CPTED PUBLIC SAFETY/SECURITY DRAWING LEGEND	
KEY	DESCRIPTION
AC	ACCESS
LS	VANDAL-PROOF MOTION SENSOR ACTIVATED SECURITY LIGHT
PS	PHYSICAL - FENCING, WALLS, PLANTINGS
SN	SURVEILLANCE NATURAL - WINDOWS
TR	TERRITORIAL REINFORCEMENT/ BOUNDARY DEFINITION
WS	WARNING SIGN (BROWARD SHERIFF'S OFFICE NO TRESPASS)

DRC

P225-12000009

SOUTH RIVERSIDE DRIVE

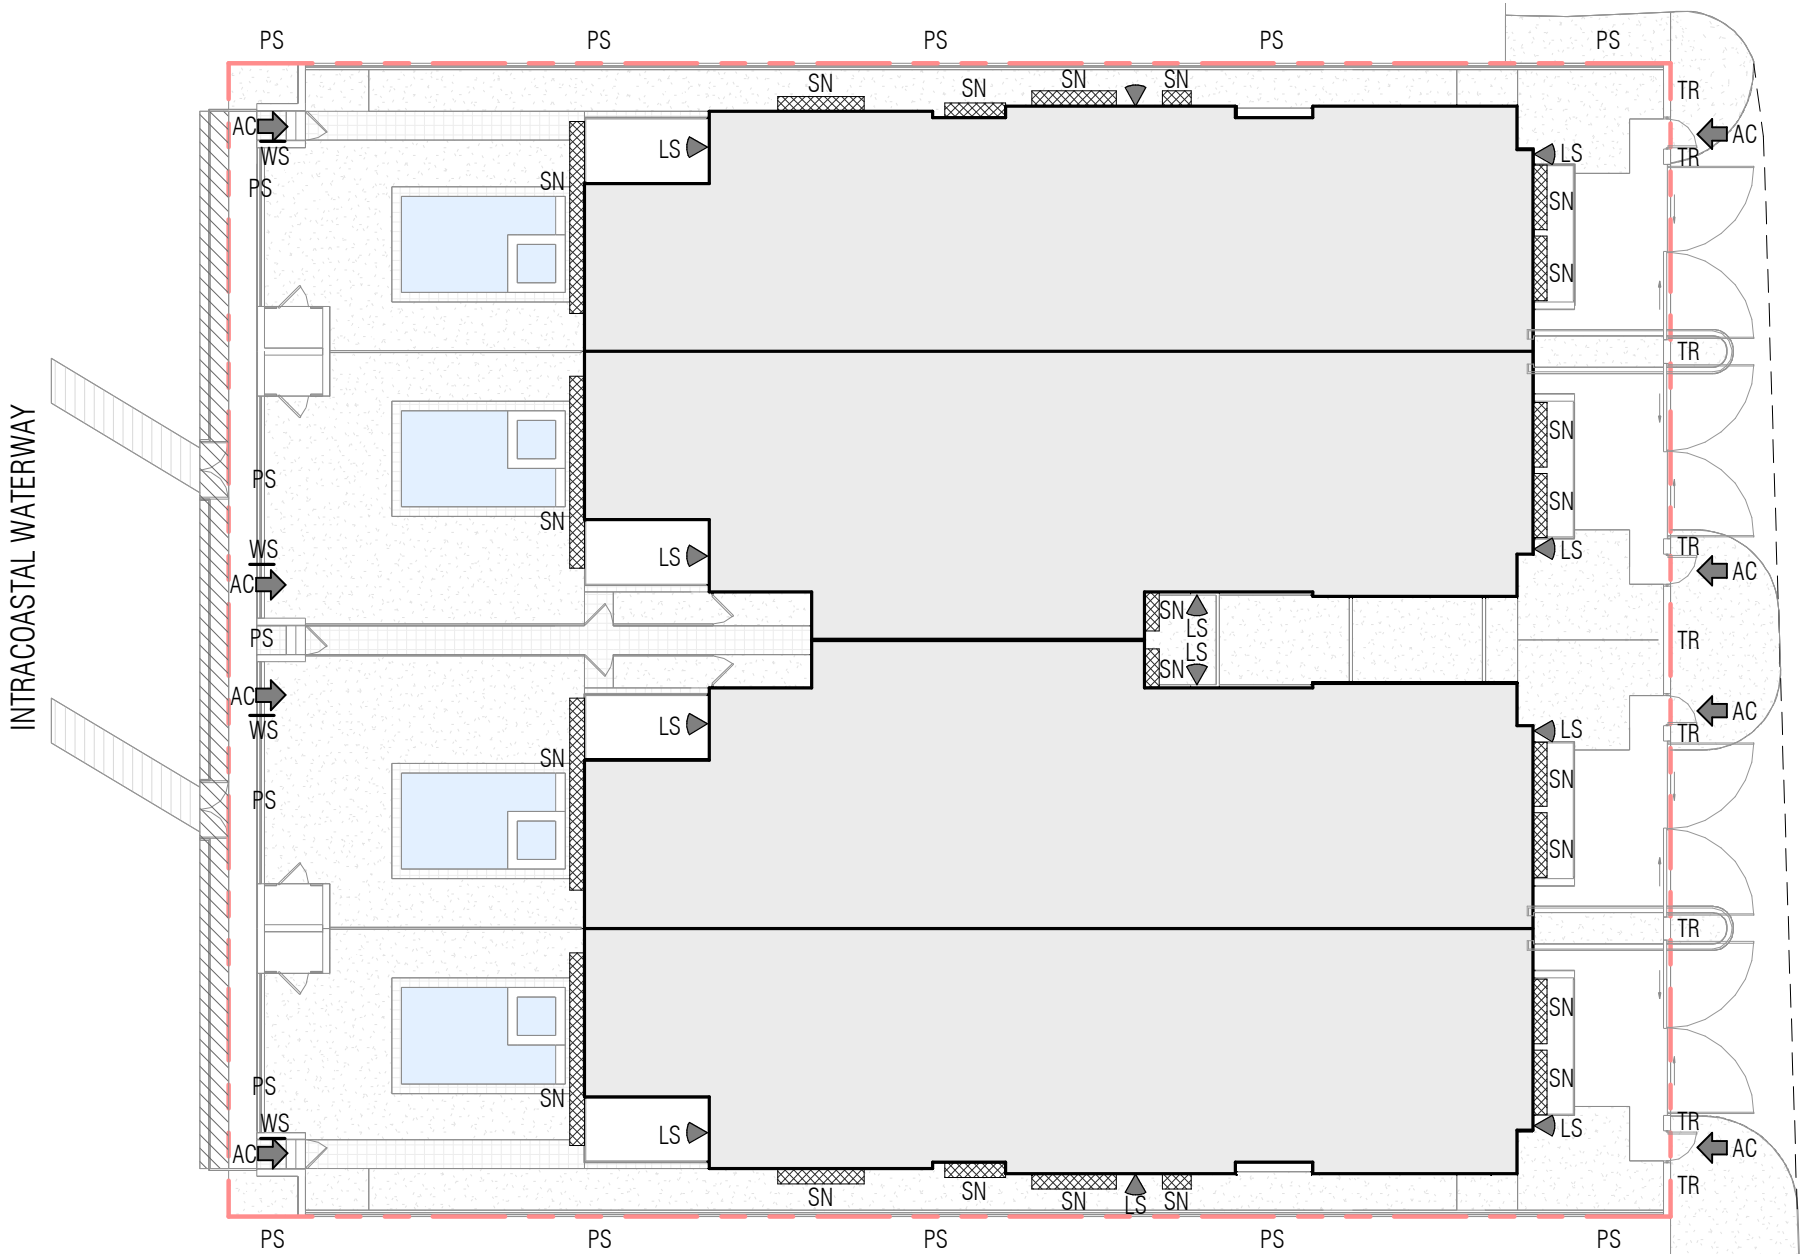
- IT IS NOTED THAT BSO RECOMMENDS INSTALLING VANDAL-RESISTANT, MOTION-SENSOR SECURITY ALERT LIGHTS OVER ALL EXTERIOR UNIT DOORS AND OVERHANGS—including main entries, garage doors, side garage egress doors, storage rooms, and sheds (if any)—AND THIS WILL BE INCORPORATED INTO THE PROJECT DESIGN AS APPLICABLE.

• IT IS NOTED THAT BSO RECOMMENDS CONCENTRATING SECURITY LIGHTING AT KEY ACCESS POINTS SUCH AS GATEWAYS, DOORWAYS, AND WINDOWS, WHILE AVOIDING OVER-ILLUMINATION AND THE CREATION OF SHADOWS, AND THIS WILL BE INCORPORATED INTO THE PROJECT DESIGN AS APPLICABLE.

• IT IS NOTED THAT BSO RECOMMENDS THE USE OF BRIGHT, SOFT LED LIGHTING WITH SHIELDED FIXTURES TO IMPROVE NIGHTTIME VISIBILITY WHILE MINIMIZING GLARE AND LIGHT POLLUTION TRESPASS, AND THIS WILL BE INCORPORATED INTO THE PROJECT DESIGN AS APPLICABLE.

• IT IS NOTED THAT BSO RECOMMENDS COORDINATING LIGHTING PLACEMENT TO SUPPORT SECURITY CAMERA OPERATION BY AVOIDING DIRECT ILLUMINATION INTO CAMERA LENSES, AND THIS WILL BE INCORPORATED INTO THE PROJECT DESIGN AS APPLICABLE.

• IT IS NOTED THAT BSO RECOMMENDS INCORPORATING PEDESTRIAN-SCALE LIGHTING ALONG DESIGNATED PEDESTRIAN TRAVEL PATHS SUCH AS SIDEWALKS, PARKING AREAS, AND RECREATIONAL WALKWAYS, AND THIS WILL BE INCORPORATED INTO THE PROJECT DESIGN AS APPLICABLE.

• IT IS NOTED THAT BSO RECOMMENDS HARDWIRING OR PREWIRING EACH RESIDENTIAL UNIT FOR BURGLAR ALARMS AND ENCOURAGING RESIDENTS TO USE SECURE SAFES FOR VALUABLES; THESE MEASURES WILL BE INCORPORATED INTO THE PROJECT DESIGN AS APPLICABLE.

• IT IS NOTED THAT BSO RECOMMENDS DESIGNING FENCING TO SUPPORT NATURAL SURVEILLANCE USING CPTED-COMPLIANT MATERIALS SUCH AS SEE-THROUGH STEEL RAIL FENCING, AND THIS WILL BE INCORPORATED INTO THE PROJECT DESIGN AS APPLICABLE.

• IT IS NOTED THAT BSO RECOMMENDS INSTALLING ROBUST ANTI-PRY SECURITY BARS ON ALL GROUND-LEVEL AND SECOND-FLOOR SLIDING GLASS DOORS, AND THIS WILL BE INCORPORATED INTO THE PROJECT DESIGN AS APPLICABLE.

• IT IS NOTED THAT BSO RECOMMENDS SECURING ALL PUBLICLY ACCESSIBLE EXTERIOR ELECTRICAL OUTLETS WITH LOCKABLE METAL COVERS AND INTERNAL CUTOFF SWITCHES, AND THIS WILL BE INCORPORATED INTO THE PROJECT DESIGN AS APPLICABLE.

• IT IS NOTED THAT BSO RECOMMENDS SECURING ALL PUBLICLY ACCESSIBLE EXTERIOR WATER SPIGOTS WITH LOCKING CAPS IN EASILY ACCESSIBLE LOCATIONS, AND THIS WILL BE INCORPORATED INTO THE PROJECT DESIGN AS APPLICABLE.

• IT IS NOTED THAT BSO RECOMMENDS PROVIDING ADDRESS SIGNAGE THAT IS CLEARLY VISIBLE FROM THE ROADWAY, UNOBSTRUCTED BY LANDSCAPING, WITH HIGH CONTRAST AND REFLECTIVE OR ILLUMINATED FEATURES FOR EMERGENCY VISIBILITY, AND THIS WILL BE INCORPORATED INTO THE PROJECT DESIGN AS APPLICABLE.
